## **Brislington meadows 22/01878/P**

Arboricultural comments November 24<sup>th</sup> 2022

8.4 Landscape parameter plan (Dwg 7456\_102). This is the only agreed vehicular access point for the proposed development.

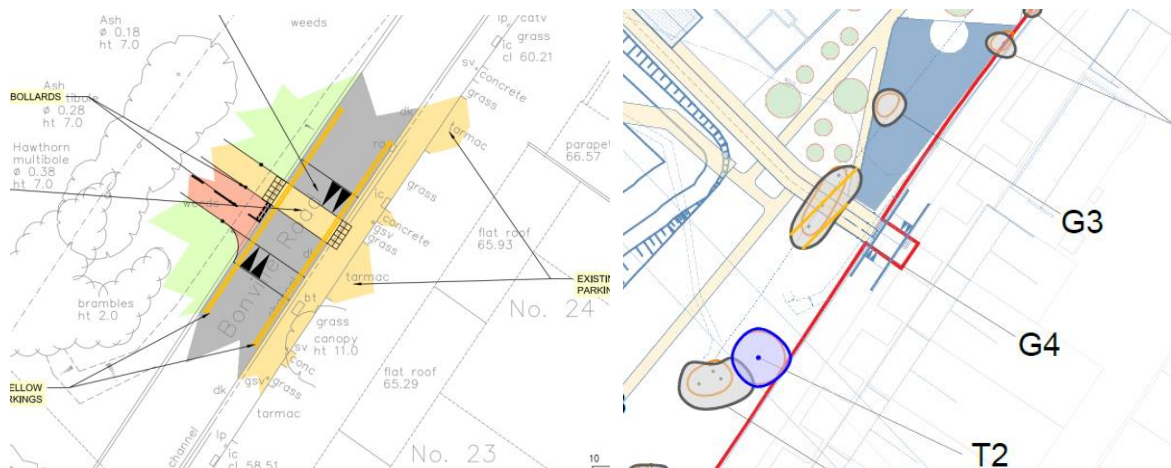
8.5 Proposed Site Access, Broomhill Road (Dwg 1066-007). G39 is proposed for retention. An arboricultural method statement and tree protection plan has not been provided to demonstrate this group can be retained and provide working methodologies to facilitate this access. The onward movement of this access point has the potential to affect W2 a 'Habitat of Principle Importance' (TEP arboricultural report; 3.13 Habitats of Principles Importance) and T15 Oak included with TPO 1404 (trees TPO number referenced); further details of tree removals and tree protection will need to be secured by reserve matters.

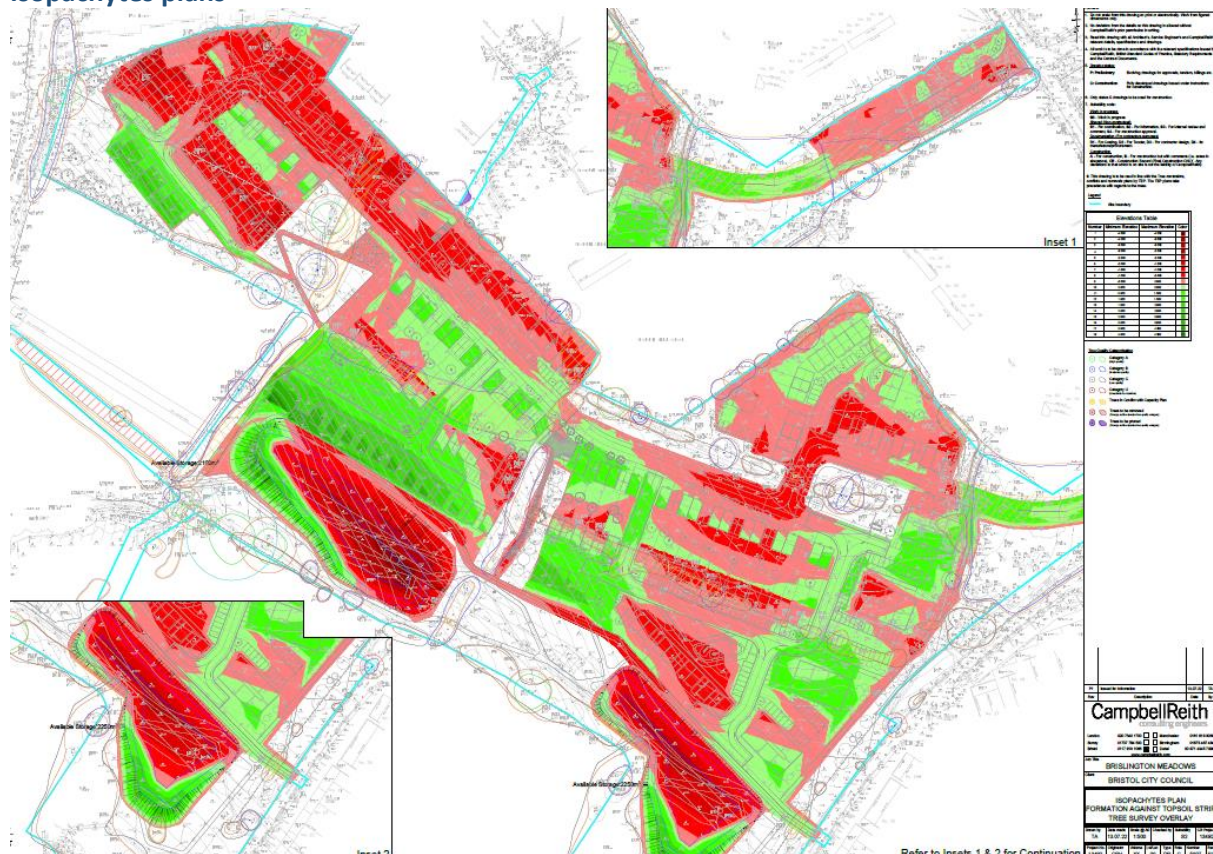
11.7 The outline application has not responded to the site allocations and therefore important trees and hedgerows have been proposed for removal. Further the additional supporting Isopachy plan demonstrates the site wide reprofiling that will permanently alter a site that is recognised

as having city-wide importance for nature conservation due to the presence and condition of particular species, habitats and/or features.

### Earth works

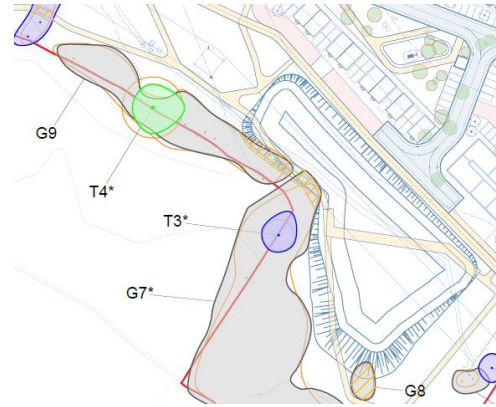
12.5 The supporting indicative plans suggests extensive reprofiling of the landform to facilitate the proposed that does not consider the existing site ecology, historic field network or Important trees and hedgerows. The excavations and fill are in close proximity to retained trees and hedgerows and no working space has been identified. These works therefore have the potential to adversely affect these features.

12.6 The indicative proposed water attenuation in the western corner of the site, is located on the outer limits of the root protection area of the recognised veteran tree, T6 Oak, and the southern hedgerow boundary. An increase of 3m of heavily compacted fill in this area has the potential to affect ground water hydrology which could adversely affect the rooting environment of this tree. There is no working space between the tree's root protection area and the fill and therefore without a high level of supervision there is the risk of damage to the veteran tree.

12.7 The indicative water attenuation area in the southern section of the site requires the partial removal of groups G7 & G9. The proposed removal of part of the group is on the line of fill, and therefore in reality more extensive removal will be required to facilitate these earth works; again no working space has been allowed for.

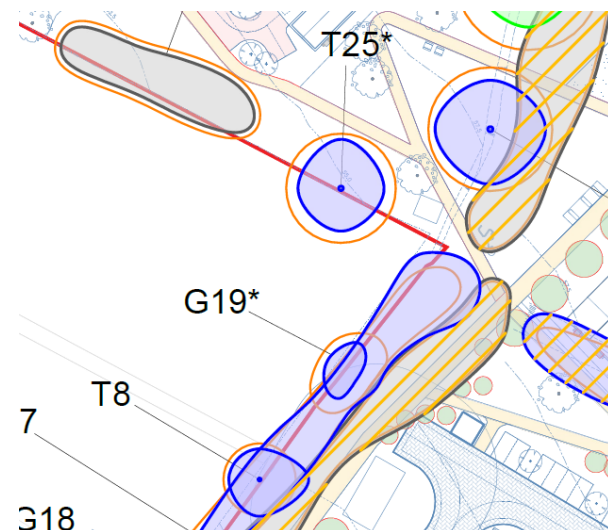
12.8 The only section of important hedgerow proposed for retention G10 has significant earthworks on either side which is likely to lead to the loss of this feature.

12.9 The indicative addition of up to 3m of material to facilitate a footpath on north-western boundary of the site adjacent to the allotments and within the root protection areas of T8 &

G19 (Which includes Holly T6 TPO 1404) has the potential to adversely affect the rooting environment of the trees which can lead to their decline and early loss.
